Application for Works Approval Amendment

Works Approval Number	W6724/2022/1
Works Approval Holder	Golden Spur Resources Pty Ltd
ACN	161 329 933
File Number	DER2022/000143~3
Premises	Bellevue Gold Processing Plant Bellevue Gold Project Mining tenements M36/24 and M36/25
Date of Report	1 June 2023
Decision	Revised works approval granted

Figure 2: Westralia Pit, showing proposed berm expansion and monitoring locations.

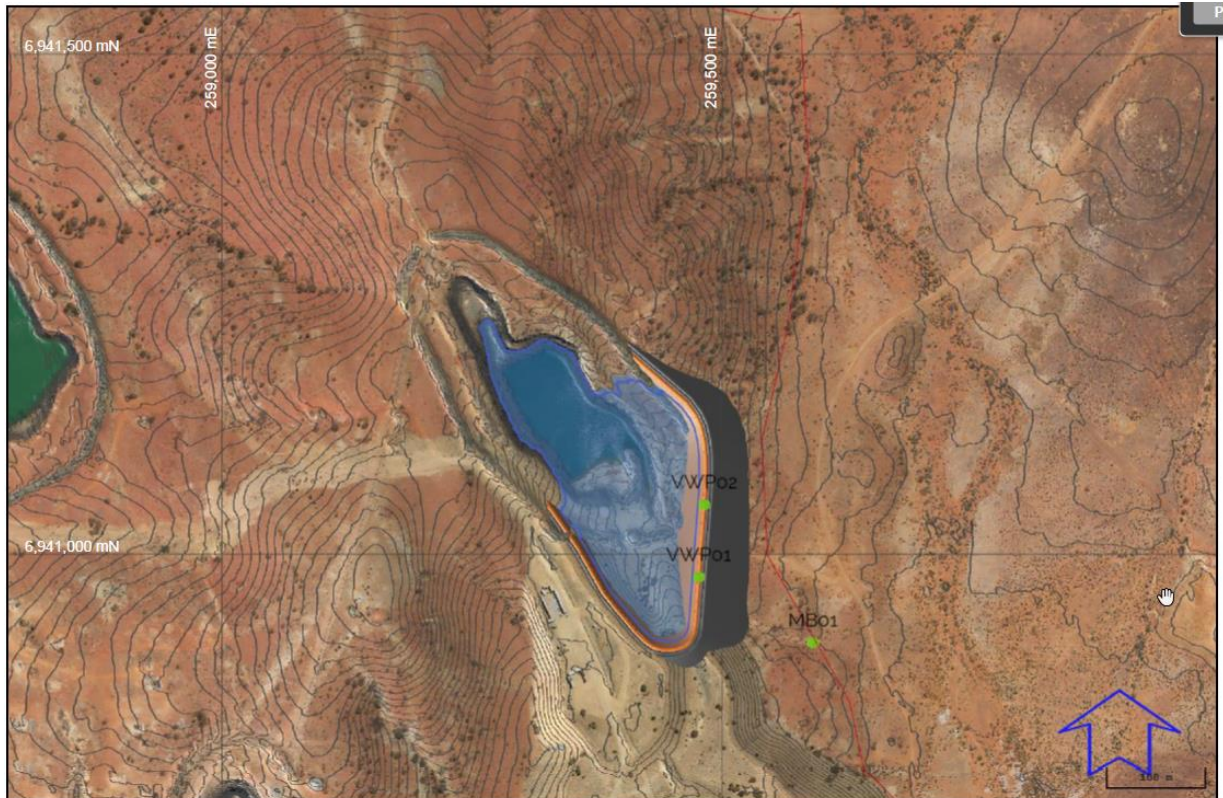
The proposed clay apron and removal of uncontrolled fill to minimise seepage from the basin outside Westralia Pit will also be required to extend up to the embankment crest level for each phase. It is unclear from the application if this is the proposed extent of the apron, but the Delegated Officer considers this a reasonable control.

The rate of seepage through the upper meters of the Westralia Pit is unknown, but likely to be similar to the lower sections of the pit. The licence holder reports that a monitoring bore installed in December 2020 was dry until May 2021 when it is believed to have been destroyed. There has been no evidence provided of exactly where this bore was constructed so the reliability of this data is low, but it does indicate that potentially no significant seepage currently originating from the Westralia Pit. It is noted however that the monitoring data only covers a few months of deposition into Westralia Pit.

Technical review of the proposal has been undertaken and it was noted that there is some uncertainty in the seepage modelling, as hydraulic conductivity values of the various geological materials used in the models were assumed on the basis of limited laboratory and field testing. Changes in these values by one or more orders of magnitude would have the potential to significantly alter the predicted seepage rates and the predicted magnitude of groundwater mounding.

1 (Table 1) - 3	Request to construct the WPBE in 2 parts - starter is stage 1 and 2 in diagram, lift is stage 3. Updated wording proposed (A2178420) Propose monitoring equipment required with Phase 2, no monitoring required for Phase 1 (expected 8-12 weeks)	<ul style="list-style-type: none"> Propose terminology of 'phase 1' (WPBE waste stage 1, and upstream layers) and 'phase 2' (WPBE waste stage 2-3, and upstream layers) DMIRS advised (A2178574) that no change to the mining proposal is required for the construction to take part in stages, provided the overall facility is unchanged. Changes to dimensions can be addressed in current amendment to Mining Proposal if required (A2178883). No objection to issue of works approval amendment. DWER has reviewed the description, risk assessment and conditions for the WPBE. It is noted that as well as the change to a two phase design, the dimensions of the embankment design have changed. The new design features stronger seepage controls as the basic components are similar but the cut-off trench and low permeability zone are wider. The total embankment width is also wider. It is therefore considered that the embankment design is still acceptable. Works approval holder proposed that all monitoring equipment (VWPs and monitoring bore) be completed in Phase 2. The Delegated Officer

Condition	Summary of Works Approval Holder's comment	Department's response
		<p>considers that monitoring equipment should be installed as early as possible. WA holder agreed to install monitoring bore at phase 1. However ongoing construction of phase 2 immediately after completion of phase 1 will make construction of VWP's difficult. The Delegated Officer has taken this into account along with the disturbed nature of the downstream environment and decided that for the short period before construction of Phase 2, VWP's are not necessary to monitor the seepage risk within the embankment.</p> <ul style="list-style-type: none"> The Licence holder is advised that DWER has not assessed whether piezometers are required for monitoring of embankment stability, and an amendment of the approved mining proposal could be required. DWER has notified DMIRS of the change in design, and proposal to operate phase 1 without piezometers. Plan and section figures updated.

1 (Table 1) – 3 d and e	Change from point location of Westralia Pit monitoring bore MB01 to defining an envelope – final location to be determined in consultation with Tjwarl people.	Proposed envelope is downstream of the WPBE. Acceptable. Replacement Figure 7 inserted to show monitoring bore envelope.
1 (Table 1) – 4a	Reworded.	Agree proposed rewording more appropriate.
2 (Table 2) – 1a	Seeking clarification as to what is meant by 'conditioned and compacted to minimise seepage'	<p>This condition requires conditioning and compacting as stated in the design report. No compaction testing regime is specified. The works approval holder should seek technical advice, including testing if required, to ensure compaction is sufficient such that seepage is comparable with the modelling provided. Assessment of future lifts will consider the extent of seepage from these initial stages.</p> <p>Query only. No change made to condition.</p>

Figure 3: Westralia Pit Berm Expansion cross section

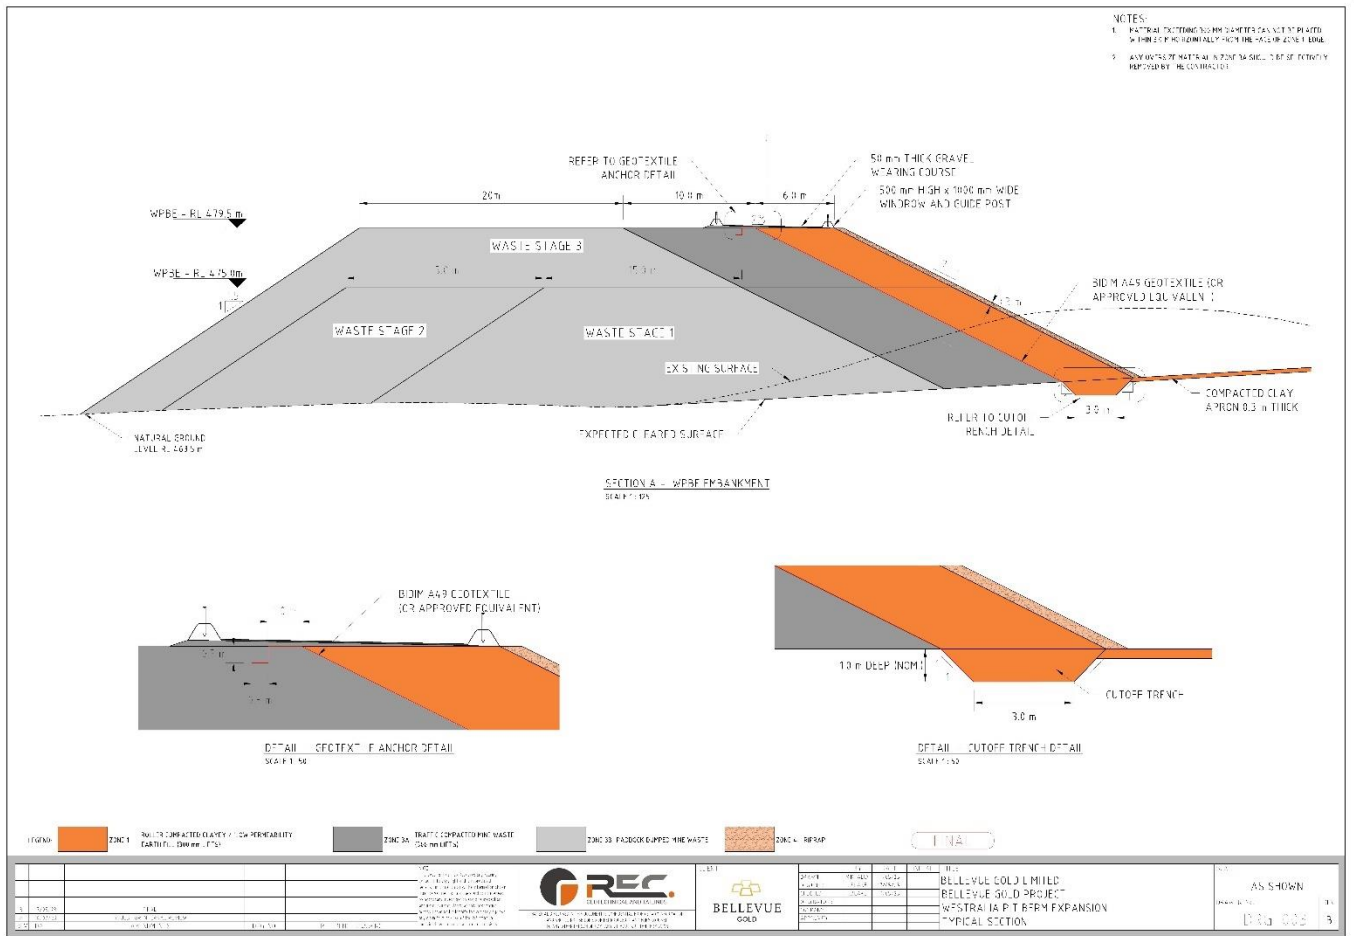
The Delegated Officer considers that the design of the berm includes reasonable controls to minimise the rate of seepage through the berm itself, including the cut off trench to minimise seepage immediately under the embankment. These will be specified in conditions of the amended works approval.

Figure 7: Tailings delivery and return water pipelines for Stage 2 TSF with position of underdrainage finger drains and sump.

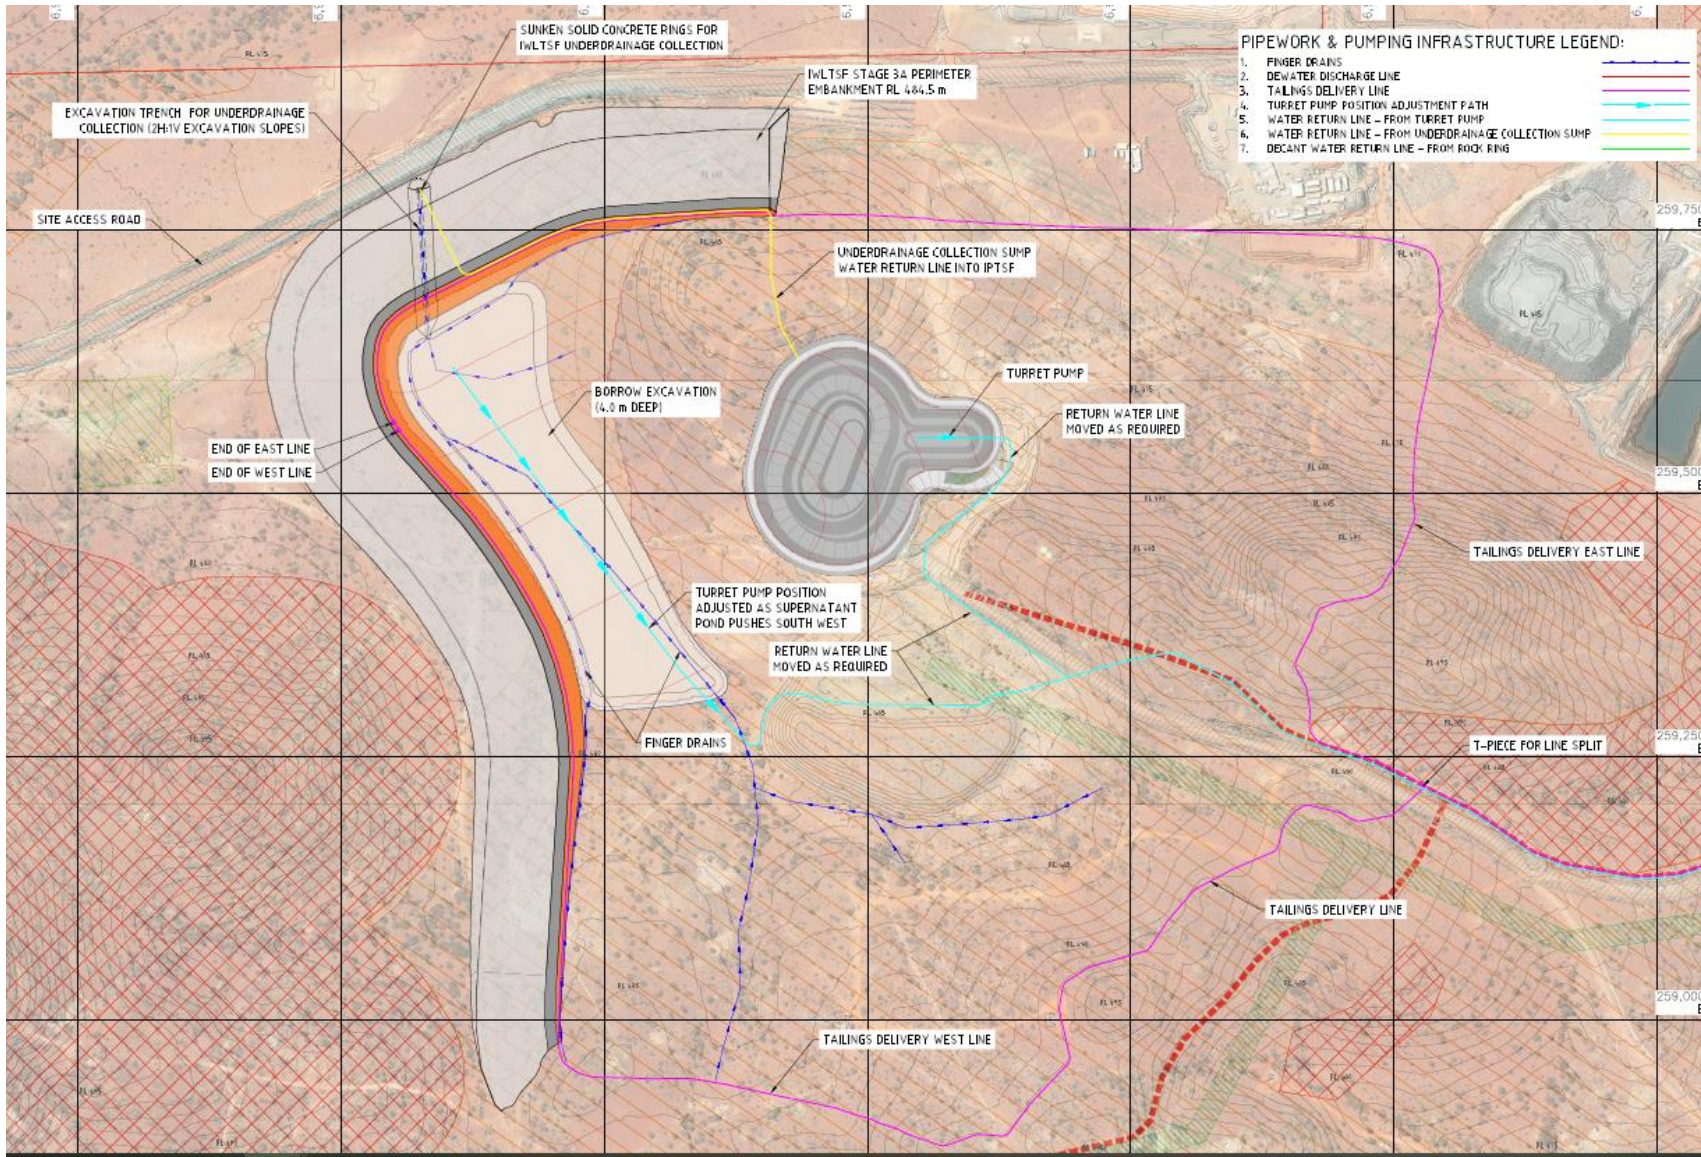
Technical review of the proposal has been undertaken and it was noted that there is some uncertainty in the seepage modelling, as hydraulic conductivity values of the various geological materials used in the models were assumed on the basis of limited laboratory and field testing. Changes in these values by one or more orders of magnitude would have the potential to significantly alter the predicted seepage rates and the predicted magnitude of groundwater mounding. Discharge monitoring has been added to the works approval during time limited operations to ensure an appropriate water balance can be developed.

Technical review also found that the proposed groundwater monitoring bores downgradient of the TSFs would not adequately capture radial seepage from the TSFs. At least three additional monitoring bores are recommended, hydraulically upgradient of the TSF/IWLTSF. A condition has been added to the works approval for the design of these additional bores by a suitable qualified hydrogeologist, and installation prior to operation of the IWLTSF.

Groundwater monitoring conditions have been added to the works approval for groundwater levels and chemistry around the TSF/IWLTSF. Monthly monitoring is required during time limited operations. Footnotes to Table 6 provide information on changes to which bores are required to be monitored over time, as the facilities progress through the planned stages.
